COUNTY OF SAN LUIS OBISPO
BOB JONES PATHWAY
(SAN LUIS OBISPO TO ONTARIO ROAD)
FINAL ENVIRONMENTAL IMPACT REPORT

SCH #2010031121

JANUARY 2015

RESPONSE TO COMMENTS

Figure 3.0-3a
Baron Canyon Bridge Detail (Option A)

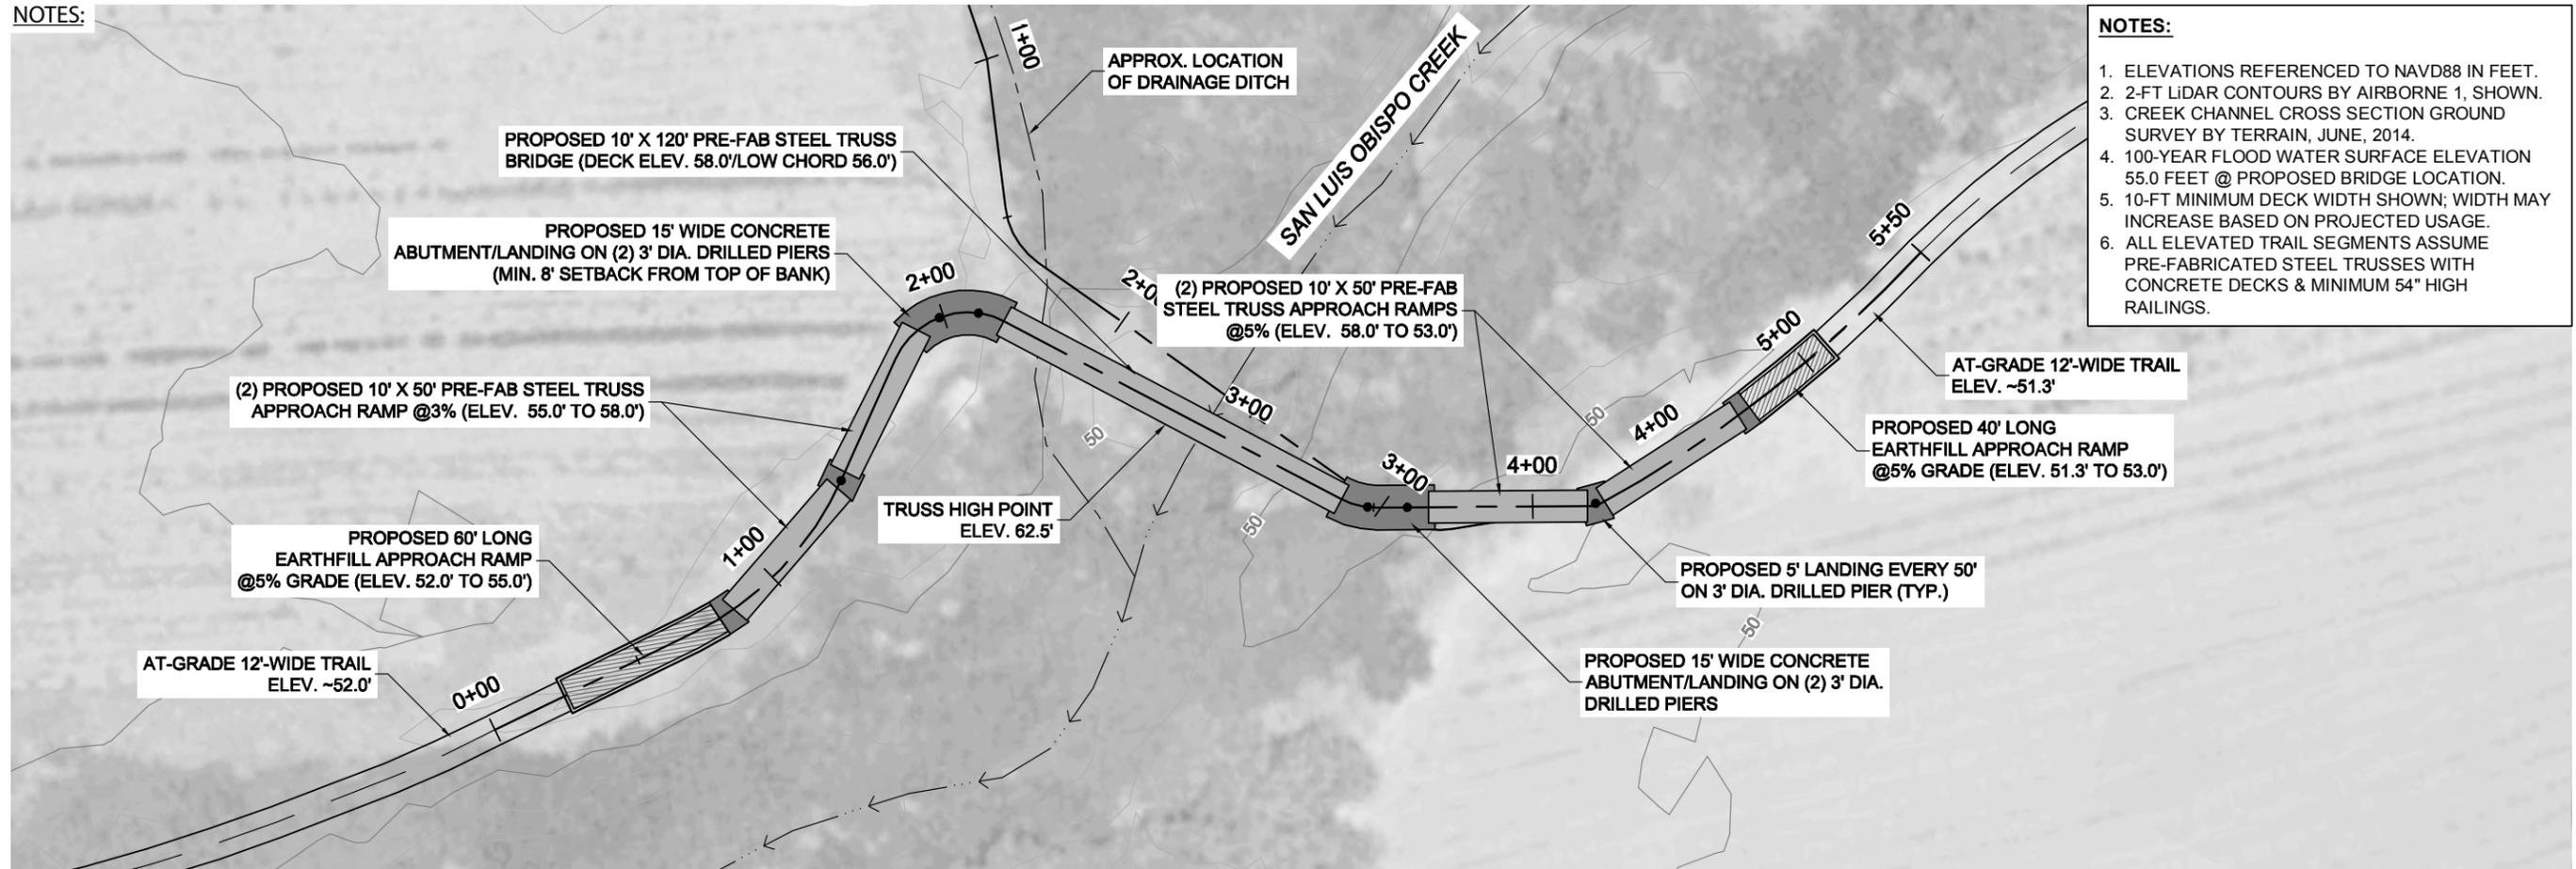
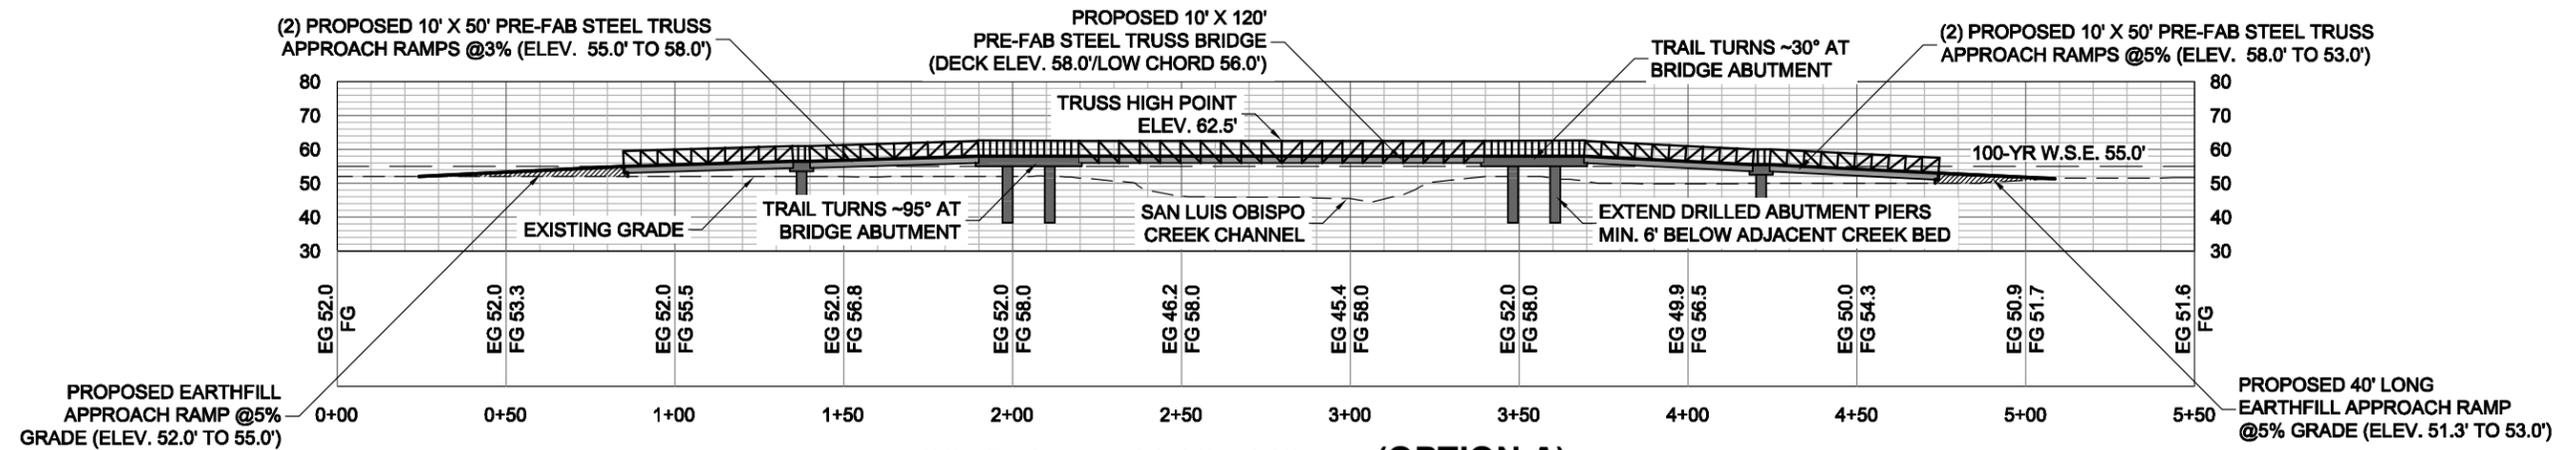
RDEIR Figures 3.0-3a and 3.0-3b have been updated and attached to correct minor labeling errors.
